ADDENDUM No. FOUR

Date: December 4, 2023

Project: LAS Expansion & Sewer System Improvements, ARPA Grant No. GA-0010529, MES No. 2020-48

Engineer: M.E. Sack Engineering
Hinesville, Georgia

301

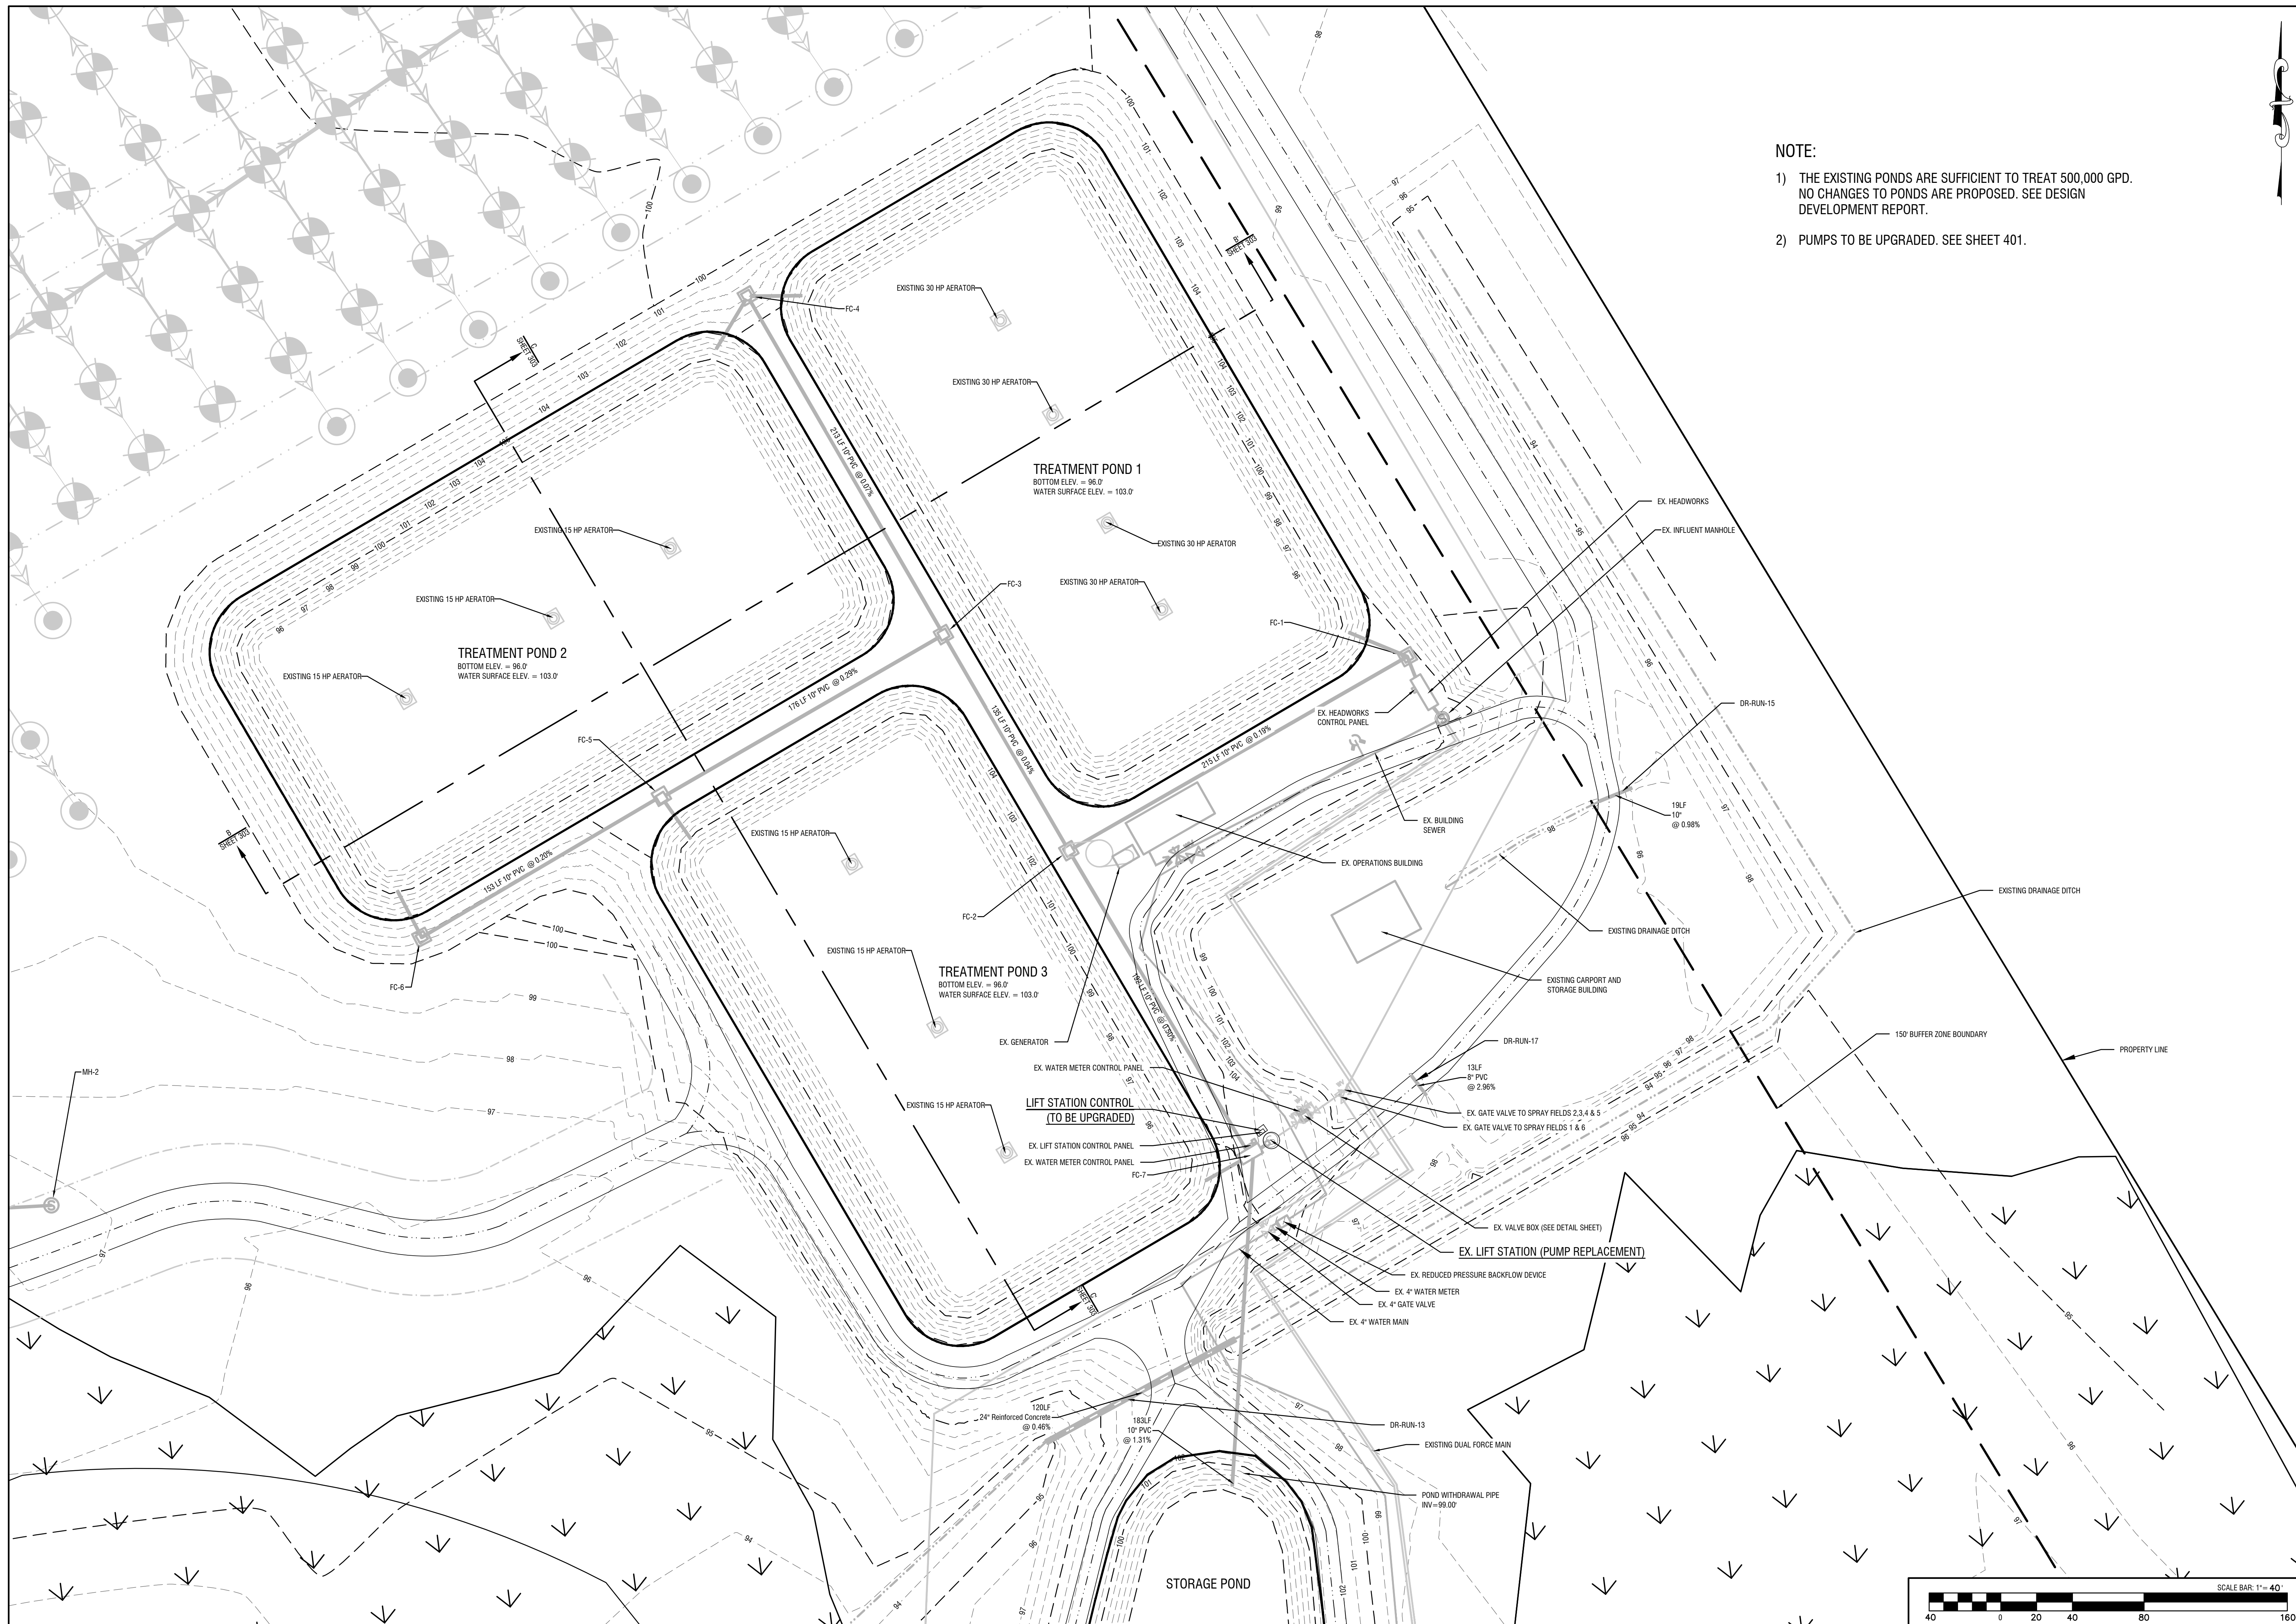
- Replace the previous Sheets 301 and 401 with the enclosed of the same. Note the notes have been expanded to include a control upgrade and a new pump model.

- 1) THE EXISTING PONDS ARE SUFFICIENT TO TREAT 500,000 GPD. NO CHANGES TO PONDS ARE PROPOSED. SEE DESIGN DEVELOPMENT REPORT.
- 2) PUMPS TO BE UPGRADED. SEE SHEET 401.
